Access Compliance Report

Public Rights-of-Way

(Curb Ramps)

Intersection ID: 24751	Main Street: CINNAMON_FIELD_RD	Cross Street: WILD_HEATHER_CT	Location: NW
ADA ID: 425A63D1AD5F	Ramp Type: Perp	Initial Pass/Fail: Fail	Overall Compliance: No
			Severity Score: 33.75
Codes/Mitigation Info/Possible Solution		Field Measurements/Component Compliance

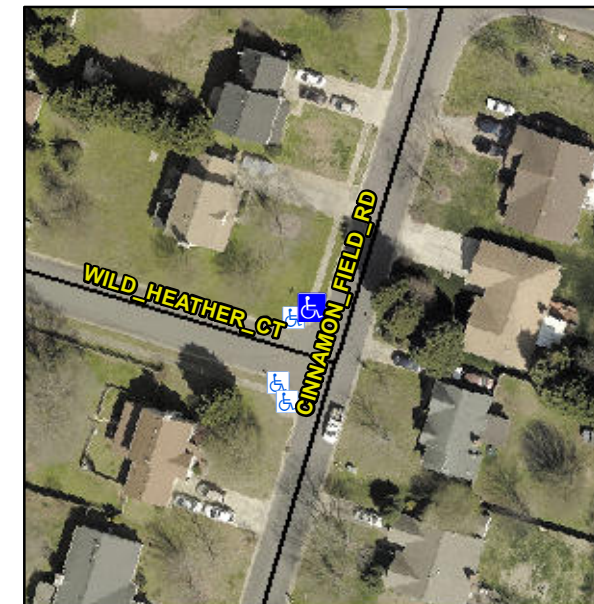
Not Found, R304.5.1, R304.2.2, R304.5.3

Compliance	Description	Data	Compliance	Description	Data
N/A	Ramp Length (in)	92.0	No	Ramp Slope (%)	10.1
No	Ramp Width (in)	36.0	No	Ramp XSlope (%)	6.5
N/A	Flare Type LT	N/A	N/A	Flare Type RT	N/A
N/A	Flare Slope LT (%)	N/A	N/A	Flare Slope RT (%)	N/A
N/A	Flare Traversable LT?	N/A	N/A	Flare Traversable RT?	N/A
N/A	Landing Length (in)	N/A	N/A	DWS Provided?	N/A
N/A	Landing Width (in)	N/A	N/A	DWS Contrast?	N/A
N/A	Landing Slope (%)	N/A	N/A	DWS Length (in)	N/A
N/A	Landing X Slope (%)	N/A	N/A	DWS Full Width?	N/A
N/A	Landing Curb? (Y/N)	N/A	N/A	DWS Offset (in)	N/A
N/A	Shared Landing?	N/A			
N/A	Gutter Ponding?	N/A	N/A	Gutter Slope (%)	N/A
N/A	Gutter Lip Ht (in)	N/A	N/A	Gutter X Slope (%)	N/A
N/A	Painted X Walk1?	No	N/A	Painted X Walk2?	N/A
	X Walk 1 Direction	To SE		X Walk 2 Direction	N/A
N/A	X Walk 1 Width (in)	N/A	N/A	X Walk 2 Width (in)	N/A
	X Walk 1 Slope (%)	0.4		X Walk 2 Slope (%)	N/A
	X Walk 1 X Slope (%)	2.8		X Walk 2 X Slope (%)	N/A

Remove & Replace Entire Ramp.
